**SUNDRY NOTICES AND REPORTS ON WELLS**  
**Do not use this form for proposals to drill or to re-enter an abandoned well. Use Form 3160-3 (APD) for such proposals.**

8. Well Name and No.  
H B 10 Federal #4

2. Name of Operator  
DEVON ENERGY PRODUCTION COMPANY, LP

**PROPOSED PLUG & ABANDONMENT**

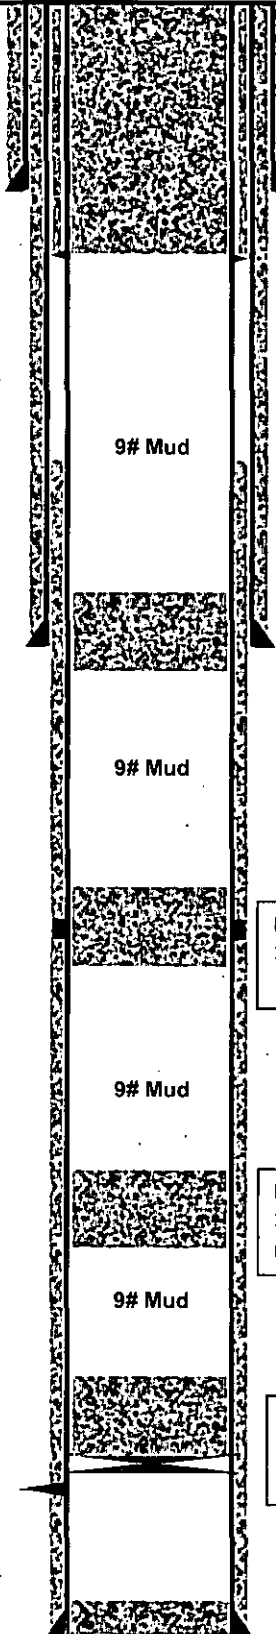
Proposed:  
 3. Cut wellhead off. Set dry hole marker.  
 2. Pump 160 sx CI C in/out to surface.  
 1. Perf csg @ ~~580'~~ **750**  
 (T.Salt @ 698'; Shoe @ 389')

Proposed:  
 1. Spot 25 sx (250') CI C @ ~~6,840'~~ - 6,590'.  
 (Bone Spring @ 6,828') **6880-6630**

Proposed: **7886 7686**  
 2. Spot 25 sx (200') CI H @ ~~7,800'~~ - 7,700'. Tag.  
 1. Set CIBP @ ~~7,800'~~  
**7886**
